Docket No. 50-423
B14647

Millstone Unit No. 3
Proposed Revision to Technical Specifications
Supplementary Leak Collection and Release System
Markup Pages

October 1993

Millstone Unit No. 3
Proposed Revision to Technical Specifications
Supplementary Leak Collection and Release System
Simplified ABVS Drawing

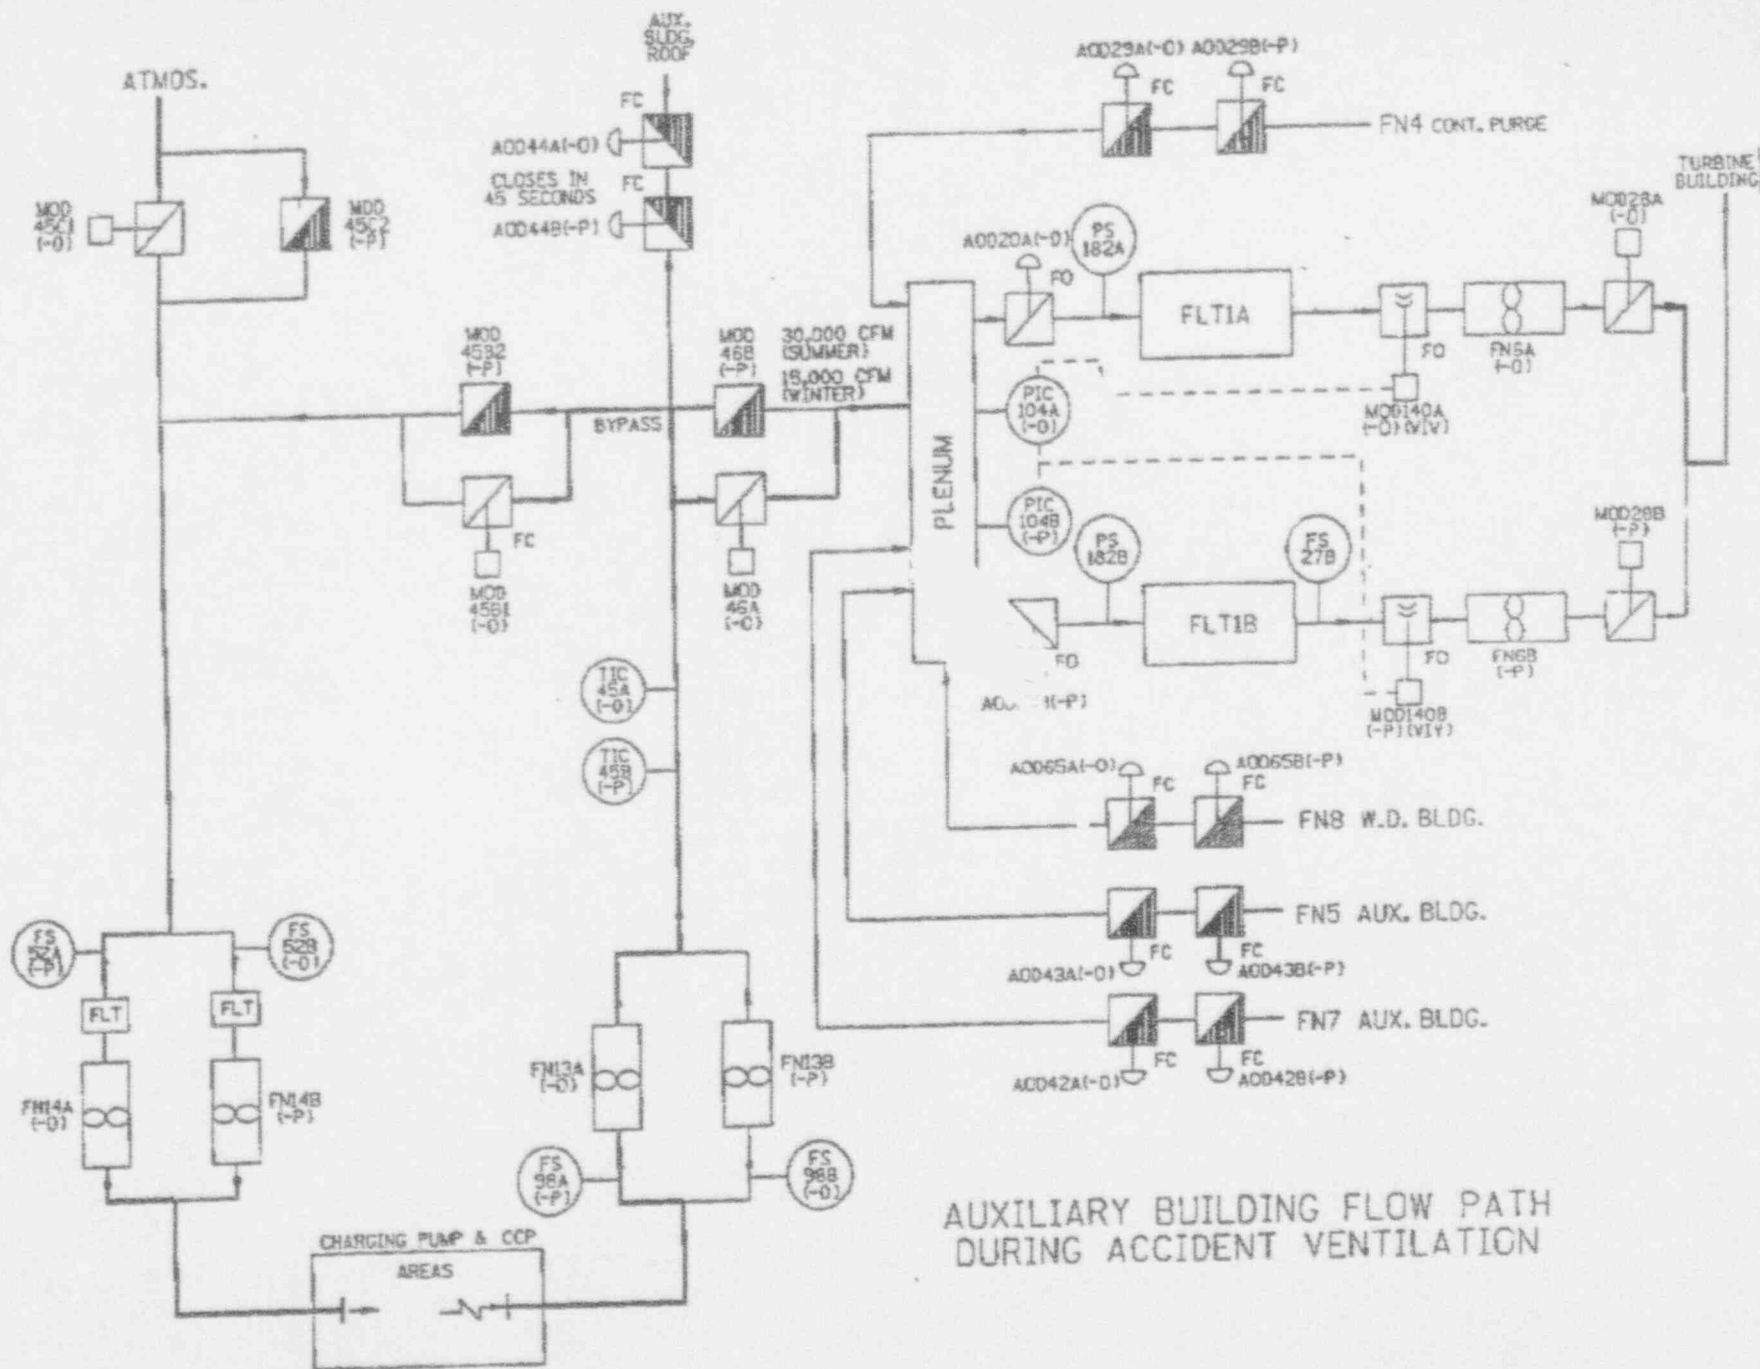
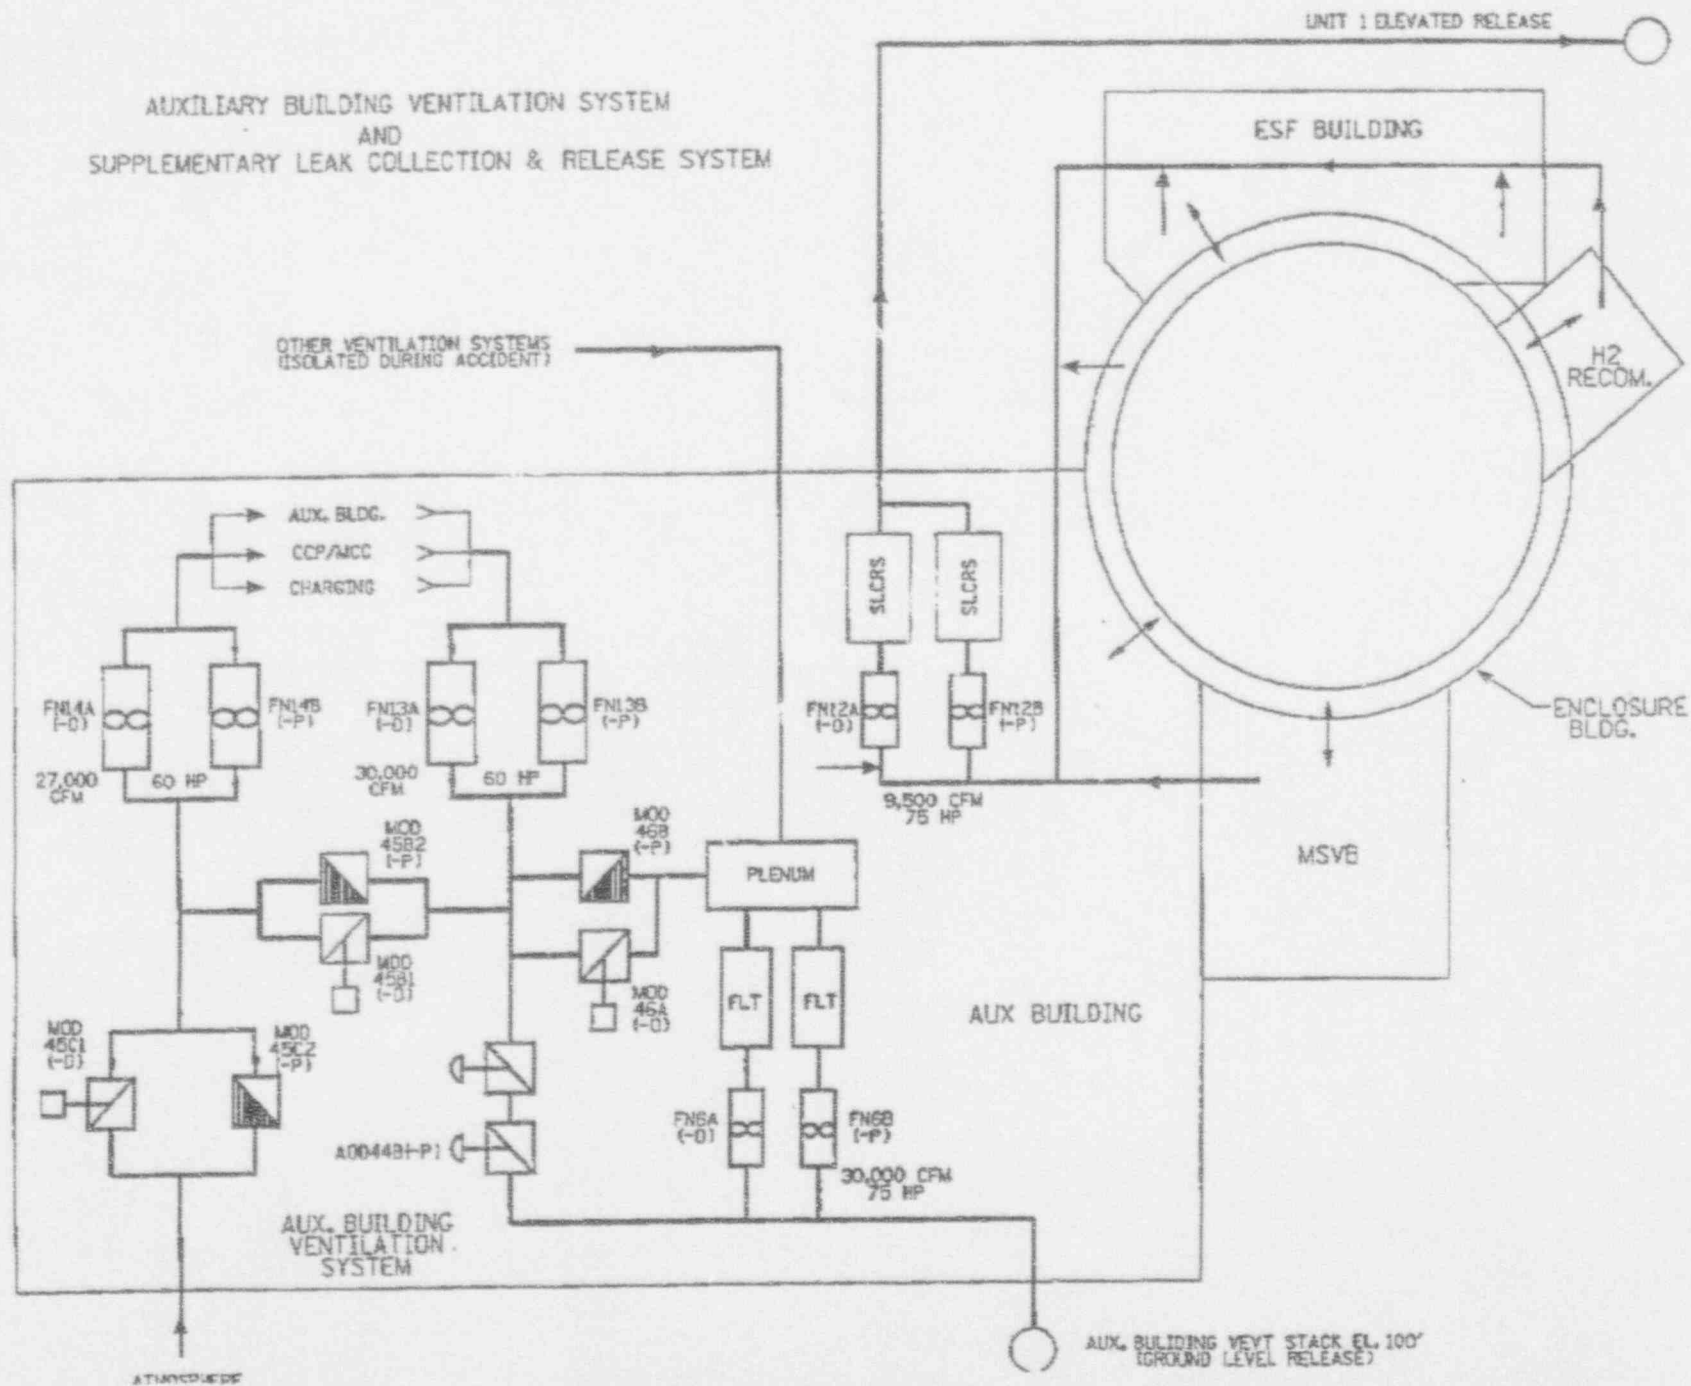
Drawdown of the Millstone Unit No. 3 secondary containment boundary to a negative pressure of 0.25 inches water gauge is required by Technical Specifications to occur within 60 seconds of receiving a safety injection signal (this time includes the diesel generator start and load time of approximately 10 seconds). For a design basis loss of coolant accident (LOCA), credit is taken for SLCRS and ABFS performance. One hundred percent of core noble gases and fifty percent of core iodines are assumed to be instantaneously released to the containment at the start of the accident. Most of the activity which leaks into the secondary containment boundary is drawn through the ventilation, filtered and reduced by a factor of 20 prior to release. The filters provide no reduction in noble gas activity. Hence, this discussion focuses on the effects on iodine thyroid dose consequences. An assessment of the dose consequences for such an event has concluded that the operation of Millstone Unit No. 3 from Modes 4 through 2 will not produce iodine curies in sufficient quantity to exceed the original filtered dose at 100% power. This assessment assumed that SLCRS and ABFS were unavailable; therefore, the release from the secondary containment boundary was unfiltered.
